From: Tybie House [Redacted]
Sent: 06 May 2026 09:01
To: Planning.Responses <Planning.Responses@arun.gov.uk>
Cc: Planning <Planning@arun.gov.uk>; Neil Crowther <Neil.Crowther@arun.gov.uk>
Subject: Public comment on application A/44/26/PL

Technical and Procedural Review of Application A/44/26/PL

This review considers the April 2026 drainage redesign presented in Application 7, in which soakaway SA1 is to be rebuilt with a base level of 7.07 m AOD and is presented as the controlling infiltration feature for the development.

Figure 1 Comparison of antecedent rainfall conditions and observed groundwater response (South East England, Nov–Apr).

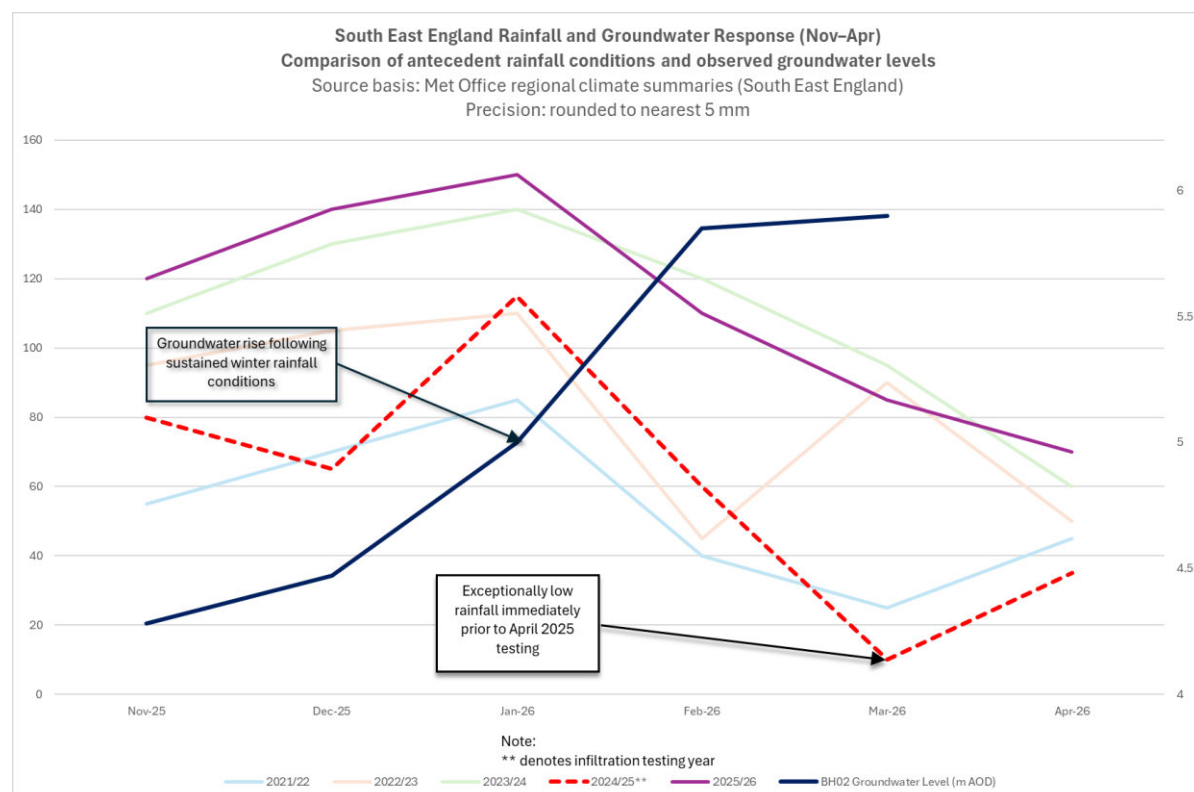
- The design value of 8.13×10^{-6} m/s may be conservative within the April 2025 dataset, but that does not make the dataset itself representative of peak winter operating conditions.

- This point remains central to the application because the rebuilt SA1 is specifically tied to the April 2025 tests. If those tests were undertaken under materially drier antecedent conditions than those prevailing when groundwater peaks, the design is vulnerable to overestimating effective infiltration performance when it is needed most.

Drawing number 21-254-702 clearly shows the drainage layout at the side of Plot 4 thus:

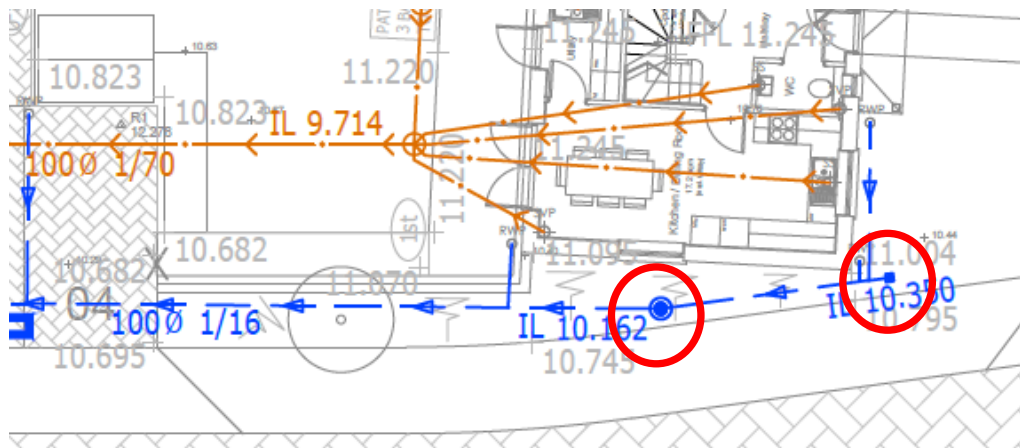
Features shown as present on the drainage drawings, including a rodding eye and inspection chamber with stated invert levels beside Plot 4, were not constructed on site. In addition, not all drainage construction drawings previously before the LPA appear to have been submitted with the present application.

This shows a rodding eye with invert level 10.350 and an inspection chamber with invert level 10.162 in the demise of plot 4.

Drainage construction details sheet 1 clearly shows the form of SW-IC4 thus:

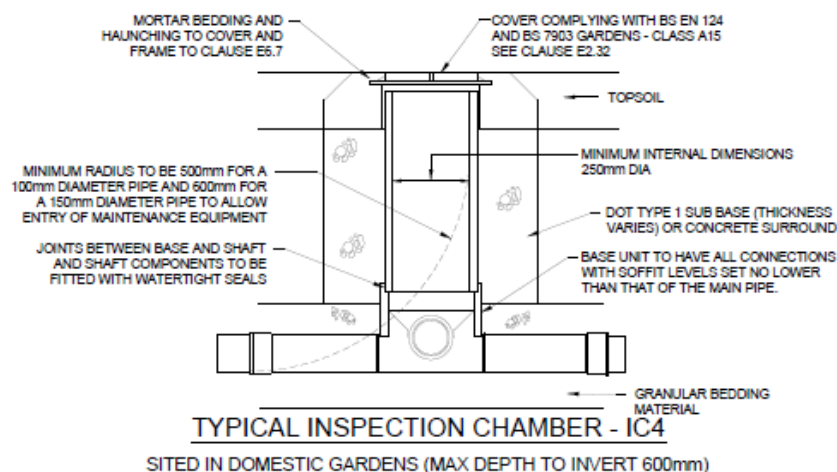
This application only contains drainage construction sheets 2 and 4 within the submitted drawings. Drawing 1 and 3 are omitted from this application, though they were submitted with the application dated 31 July 2025.

The first observation is that the complete set of drawings has not been submitted for this application, and the logical conclusion to this is that the retrospective application cannot safely be assessed as a complete and accurate as-built submission as the LPA is not in possession of all the details.
